Huntington Beach Seawater Desalination Facility Groundwater Model Evaluation

HydroFocus, Inc., Davis, CA
August 19, 2016

Executive Summary

Figure 1. Effects of changes to the Talbert Aquifer hydraulic conductivity on inland flow (a), wetland flow (b), and mean Layer 8 water level decline (c).

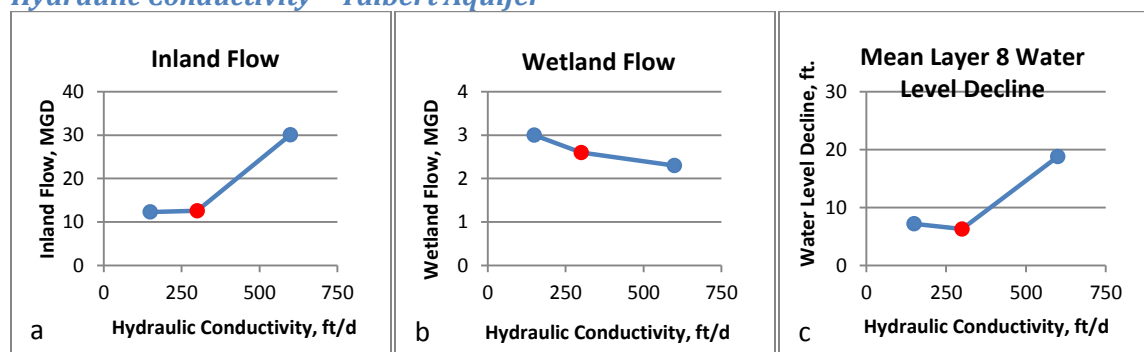
Model results are more sensitive to increases in the hydraulic conductivity of the Talbert Aquifer than to decreases. Specifically, a 100% increase in the horizontal and vertical hydraulic conductivity (these parameters were varied together) of the Talbert Aquifer resulted in significant increases in flow from the inland boundary (140%) (Figure 1a) and Layer 8 water level decline (200%)(Figure 1c). Decreasing the horizontal and vertical hydraulic conductivity by 50% had a minimal effect on inland flow and water level decline (-2% and 14%, respectively)(Figures 1a and 1c). Increasing and decreasing the hydraulic conductivity of the Talbert aquifer resulted in minimal changes to the wetland flow (-12 to 15%) (Figure 1b).

Figure 2. Effects of changes to the hydraulic conductivity in the layers overlying the Talbert Aquifer on inland flow (a), wetland flow (b), and mean Layer 8 water level decline (c).

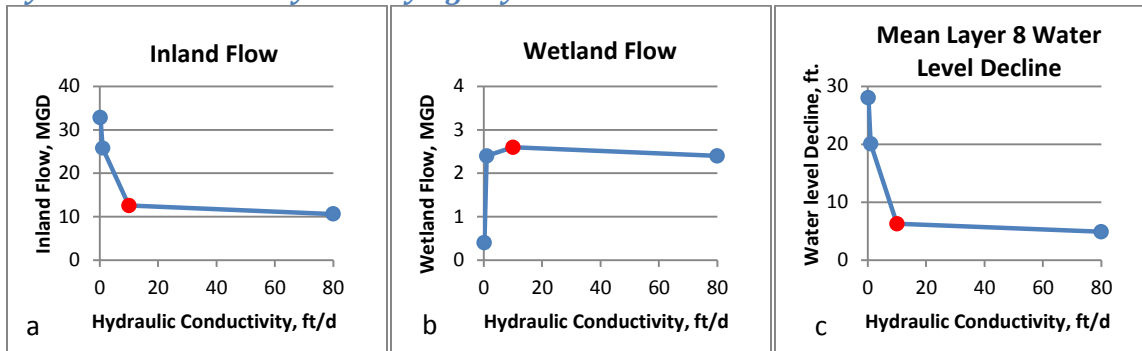
The horizontal and vertical hydraulic conductivity in the model layers overlying the Talbert Aquifer was decreased (Layer 2-4) and increased (Layers 3-4). Layer 8 water level decline was most sensitive to decreasing the hydraulic conductivity of the overlying layers (220% to 340% change in water level decline) (Figure 2c). Inland flow was also most sensitive to decreasing the hydraulic conductivity. Inland flow changed as much as 160% (Figure 2a) and wetland flow changed as much as -85% (Figure 2b) due to decreasing the hydraulic conductivity from 10 ft/d to 0.2 ft/d. Changes to inland and wetland flow and Layer 8 water level decline were relatively insensitive to increasing hydraulic conductivity.

Figure 3. Effects of changes to the hydraulic conductivity in the layers underlying the Talbert Aquifer on inland flow (a), wetland flow (b), and mean Layer 8 water level decline (c).

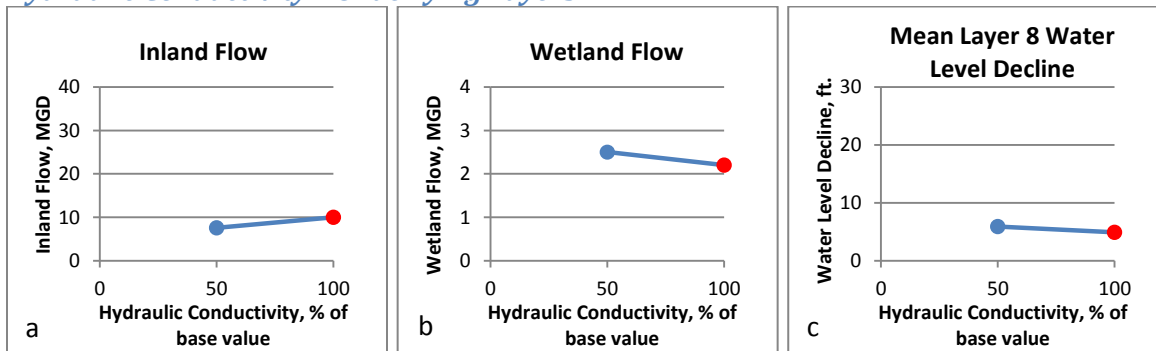
The results shown in Figures 3 through 6 were for model runs in which the specified pumping rate of was 100 MGD. The horizontal and vertical hydraulic conductivity in the underlying layers (Layers 9-10) was decreased 50%. A 50% decrease in the hydraulic conductivity of the underlying layers resulted in relatively small changes of -24%, 14%, and 20% change in inland flow, wetland flow, and Layer 8 water level decline, respectively (Figures 3a, 3b, and 3c).

Figure 4. Effects of changes to the slant well pumping rates on inland flow (a), wetland flow (b), and mean Layer 8 water level decline (c).

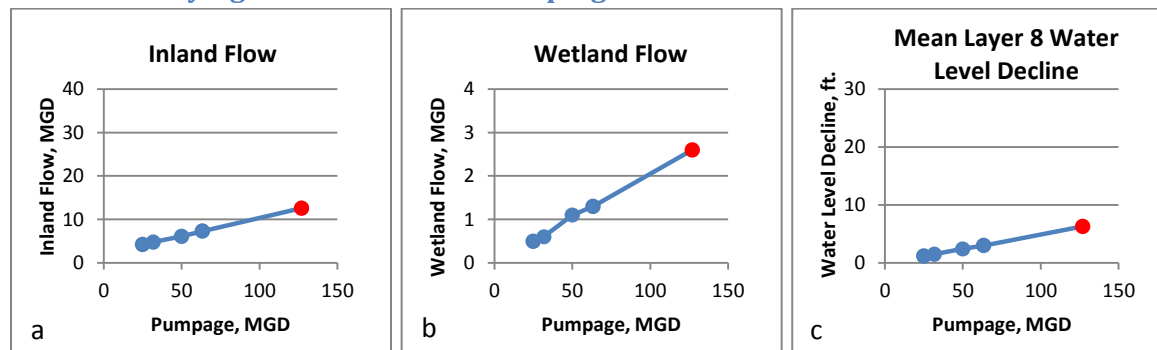
Inland and wetland flow and Layer 8 water level decline are linearly related to the slant well pumping rate. Decreases in the slant well pumping rate result in corresponding decreases in inland and wetland flow and water level decline. The relative impact of reduced pumping is greater on the wetland flow (Figure 4b) and Layer 8 water level decline (Figure 4c) (up to -81% change) than on inland flow (Figure 4a) (up to -67% change).

Figure 5. Effects of slant well screen length on inland flow (a), wetland flow (b), and mean Layer 8 water level decline (c).

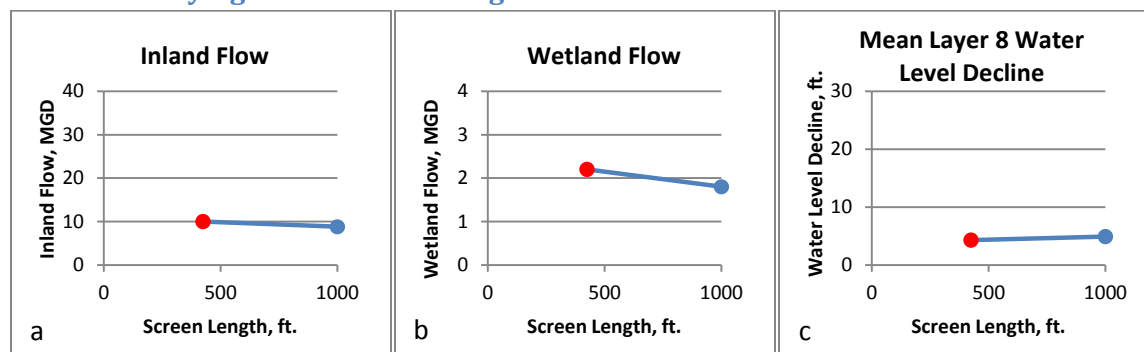
The slant well screen was lengthened and extended farther offshore than the 425-ft well screens used in the base run. These runs were made using a pumping rate of 100 MGD. A 135% increase in the well screen length resulted in relatively small changes of -12%, -18%, and 14% change in inland flow, wetland flow, and Layer 8 water level decline, respectively (Figures 5a, 5b, and 5c).

Figure 6. Effects of barrier head elevation on inland flow (a), wetland flow (b), and mean Layer 8 water level decline (c).

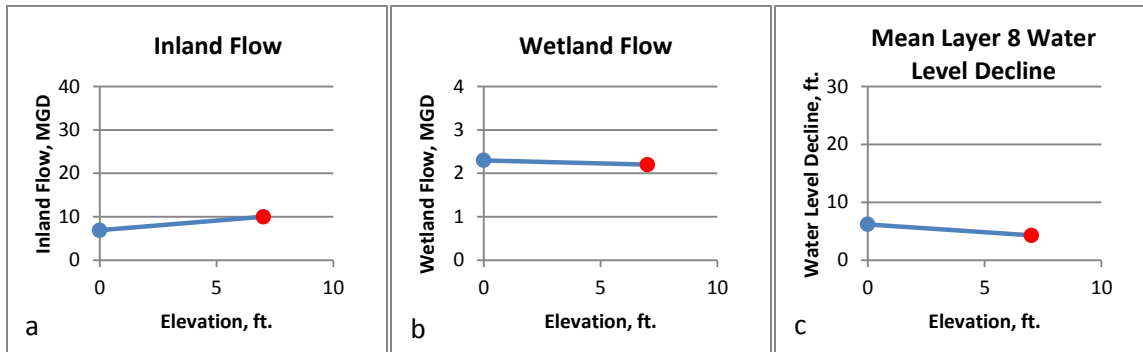
The water levels specified in the constant head cells representing the seawater intrusion barrier were reduced from the base value (about 7 ft. in Layers 2-8, 10 ft. in Layers 9-10) to 0 ft. in all layers. Because slant well pumping would create a sea water intrusion barrier, lower water levels at the Talbert Gap seawater intrusion barrier will likely result in an effective barrier¹². These runs were made using a pumping rate of 100 MGD. The change in the barrier water level resulted in a -31%, -5%, and 44% change in inland flow, wetland flow, and Layer 8 water level decline, respectively (Figures 6a, 6b, and 6c).

Figure 7. Effects of slant well location on inland flow (a), wetland flow (b), and mean Layer 8 water level decline (c).

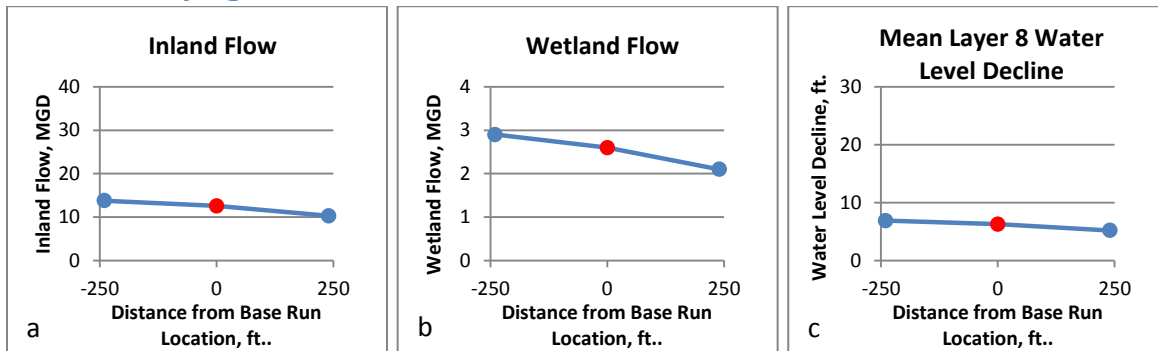
distance and the run with the well location farther seaward is shown as a positive distance from the base run location, respectively (Figures 7a, 7b, and 7c). Moving the wells farther inland resulted in relatively small changes of 10%, 12%, and 10% change in inland flow, wetland flow, and Layer 8 water level decline, respectively. Moving the wells farther seaward resulted in relatively small changes of -18%, -19%, and -17% change in inland flow, wetland flow, and Layer 8 water level decline, respectively.

Figure 8. Groundwater flow paths to the slant wells.

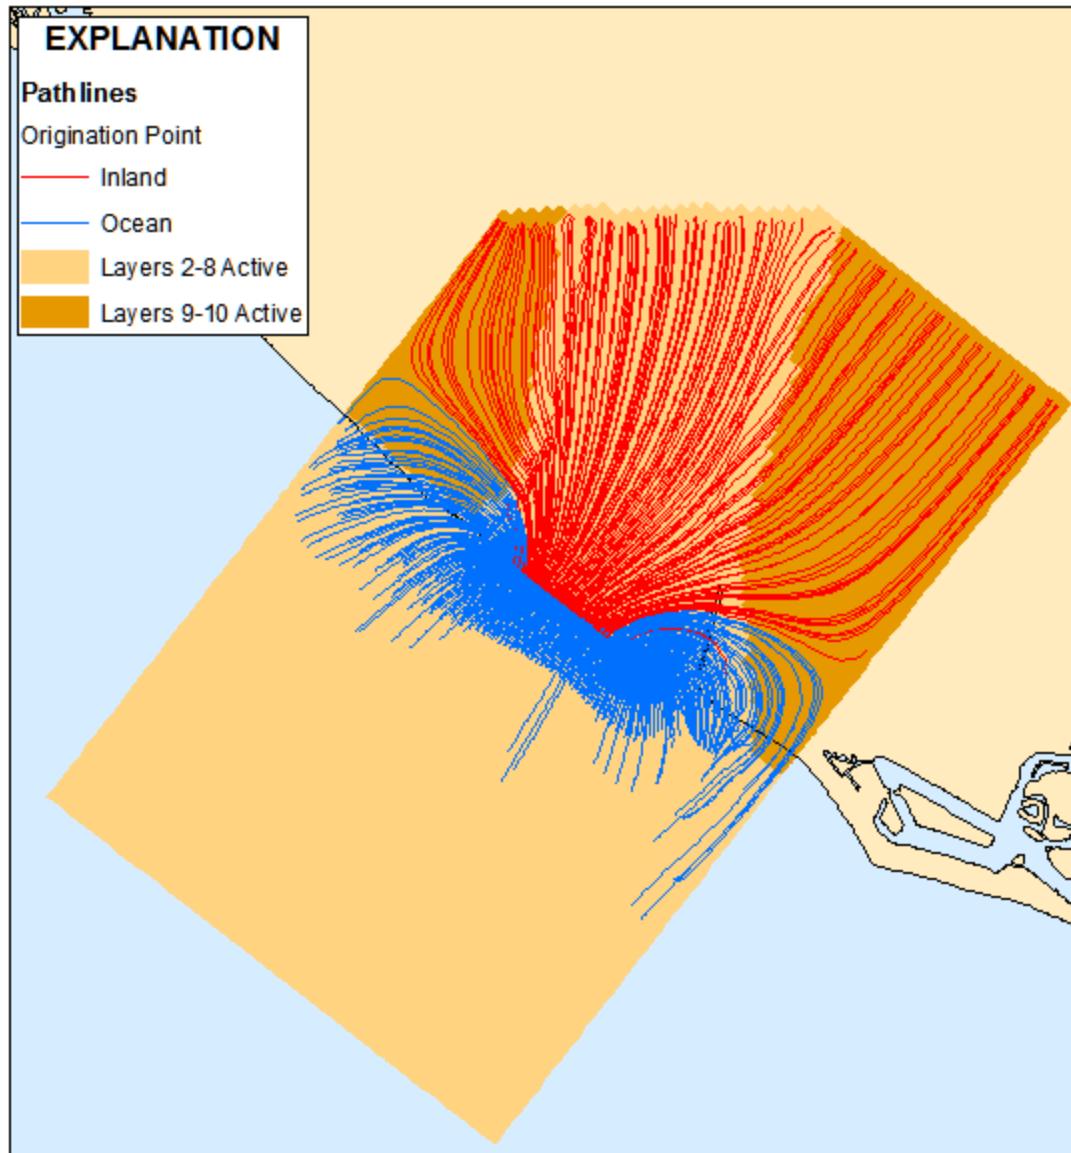
Figure 8 shows the groundwater flow paths to the slant wells (Geosyntec model 6, 127 MGD pumpage rate). Eighty-seven percent of the pathlines originate in the ocean and 13 percent originate inland. This is similar to the percentage of flow to the slant wells from the ocean and from inland (wetlands and intrusion barrier). Average travel time for the pathlines that originate near the intrusion barrier is about 20 years. Using a pumping rate of 63.5 MGD (one-half the base rate) increased the Talbert Aquifer travel time from the barrier to the slant wells to about 37 years. Using the base pumping rate of 127 MGD and setting the barrier constant heads to 0.0 ft. results in an average travel time in the Talbert Aquifer of 24 years.

Many of the pathlines in Figure 8 extend from the slant wells to the northwest and southeast toward the lateral boundaries of the model and turn sharply toward the ocean or the constant head cells representing the barrier. This sharp turn in some pathlines suggest that the simulated groundwater flow paths are being affected by the lateral extent of the model, primarily in Layers 9 and 10.

- Groundwater flow paths suggest that the model results may be affected by the lateral extent of the model domain.

Figure 9. Relation of pumpage rate and inland flow.

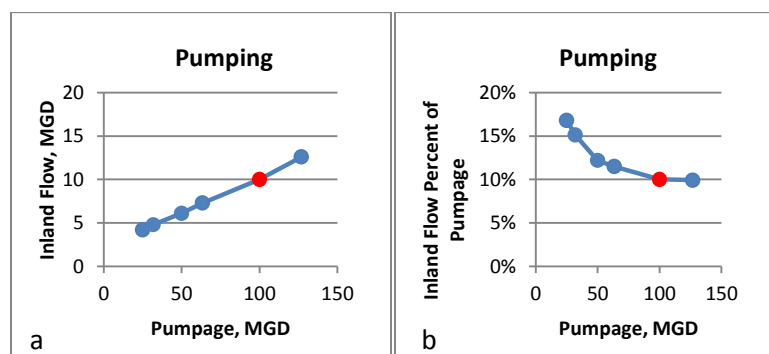
The model runs using varying pumping rates may potentially be used to select the optimum pumpage rate to minimize the proportion of pumpage originating as flow from the inland seawater intrusion barrier. The volume of water originating as flow from the inland barrier is directly proportional to the pumping rate (Figure 9a). However, the percent of the pumpage volume that originates as flow from the inland barrier is not directly proportional (Figure 9b). As the pumpage increases, the percentage of the pumpage that originates as inland flow from the barrier decreases. At pumping rates of 63.5 MGD and above, the percentage of pumpage that originates as inland flow does not change significantly.

The sensitivity results show that the specified aquifer properties and other model inputs affect the calculated percent of pumpage that originates as inland flow from the barrier. For example, using a pumping rate of 127 MGD, doubling the hydraulic conductivity of the Talbert Aquifer increased the percent of pumpage that originates as inland flow from 10% to 24%. Likewise, decreasing the hydraulic conductivity of the material overlying the Talbert aquifer up to 98% increased the percent of pumpage that originates as inland flow from 10% to 26%. Using a pumping rate of 100 MGD, increasing the hydraulic conductivity of the material overlying the Talbert Aquifer or decreasing the hydraulic conductivity of the material underlying the Talbert Aquifer decreased the percent of pumpage that originates as inland flow from 10% to 9% and 8%, respectively. Combing several changes to model input (increasing slant well length, increasing the hydraulic conductivity of the overlying material, decreasing the hydraulic conductivity of the underlying material, and lowering the water level maintained at the barrier) decreased the percent of pumpage that originates as inland flow from 10% to 4%.
